CONTRACT CHANGE ORDER NO. _____
SHEET ____ OF ____

MARK	DATE	DESCRIPTIONS	BY	CH'D	CCO#
0	04/18/12	EAST END OBG	MN	GB	87

SAN FRANCISCO OAKLAND BAY BRIDGE
EAST SPAN SEISMIC SAFETY PROJECT
SELF-ANCHORED SUSPENSION BRIDGE
(SUPERSTRUCTURE & TOWER)

EAST CABLE ANCHORAGE "E" LINE LAYOUT NO. 3B

VIEW H-H (See Note 1)
1:10

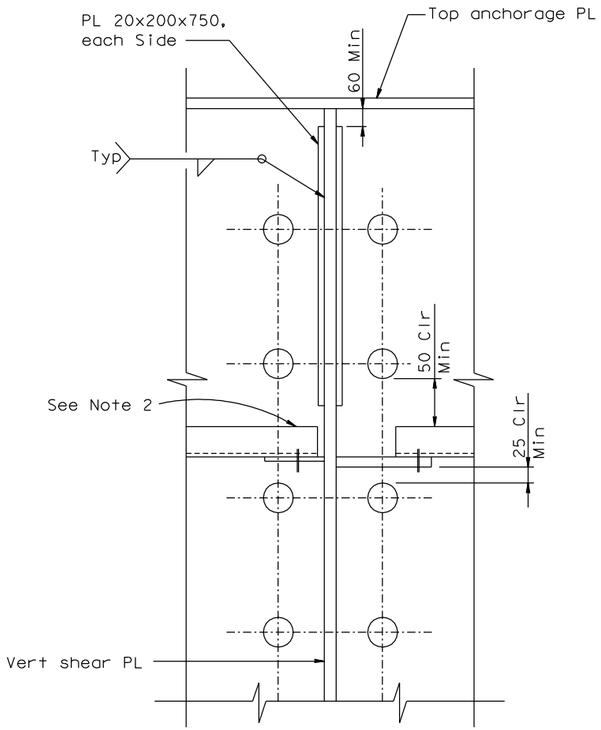
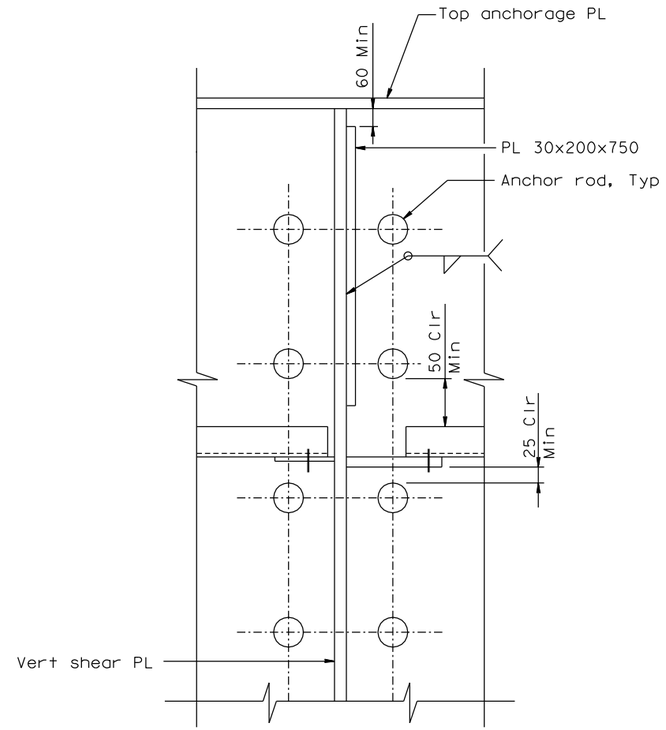
1. Use Type 1 layout at all vertical shear PL except for the two southernmost shear plates on the E-Line where Type 2 shall be used.

DETAIL E (Detail E' opposite hand)
1:10

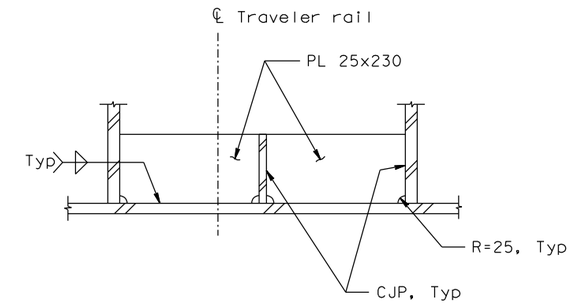
2. Trim angle as required to clear strand.
